# CITY OF ALBUQUERQUE

**RE: 7420 Long View NW**  
**Revised Grading and Drainage Plan**  
**Engineer's Stamp Date: 08/06/21**  
**Hydrology File: D12D007**

ENGINEER'S SEAL	LOT 2 BLOCK 4 RIVERTON 7420 RIVERVIEW TR. NW	DRAWN BY DEM
DAVID SOULE 14522 REGISTERED PROFESSIONAL ENGINEER	GRADING AND DRAINAGE PLAN	DATE 8-6-21
8/6/21	Rio Grande Engineering P.O. BOX 53924 ALBUQUERQUE, NM 87199 (505) 321-9099	Lot 2 Blk 4 Riverton Revised .dwg
DAVID SOULE P.E. #14522		SHEET # C1
		JOB #

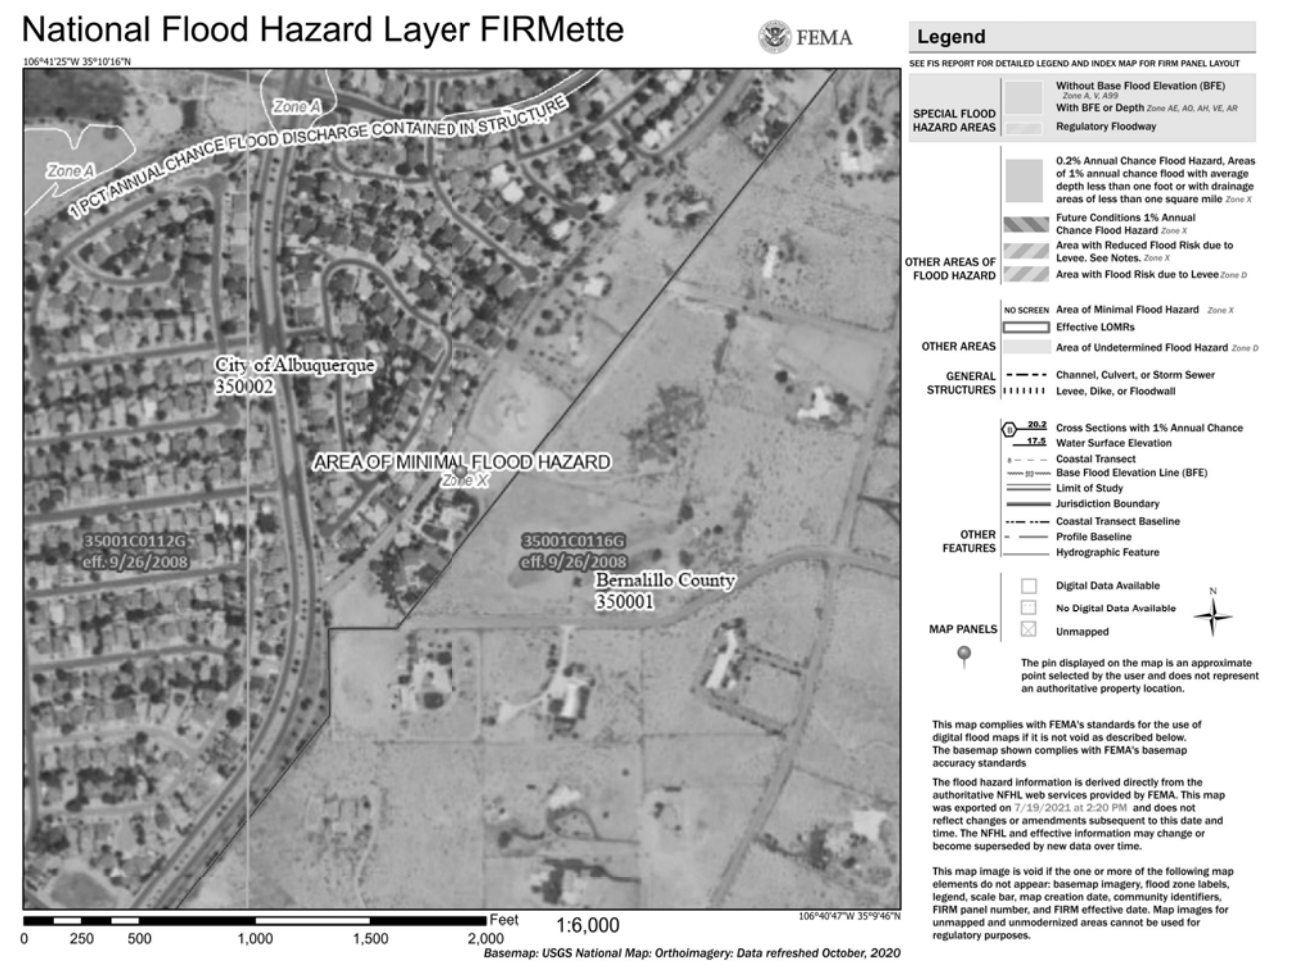
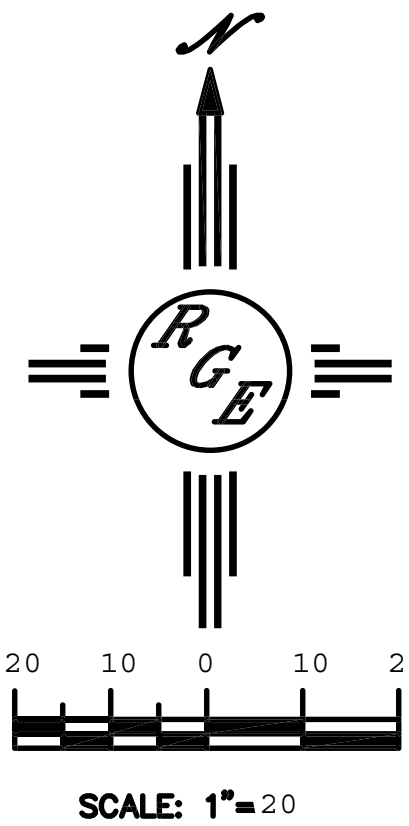
Based upon the information provided in your submittal received 08/06/2021, the Revised Grading and Drainage Plan is approved for Building Permit and Grading Permit. Since this site has an existing home and appears to have need little grading for the proposed building, a pad certification is not needed for this project.

Please attach a copy of this approved plan in the construction sets for Building Permit processing along with a copy of this letter. Prior to approval in support of Permanent Release of Occupancy by Hydrology, Engineer Certification per the DPM checklist will be required.
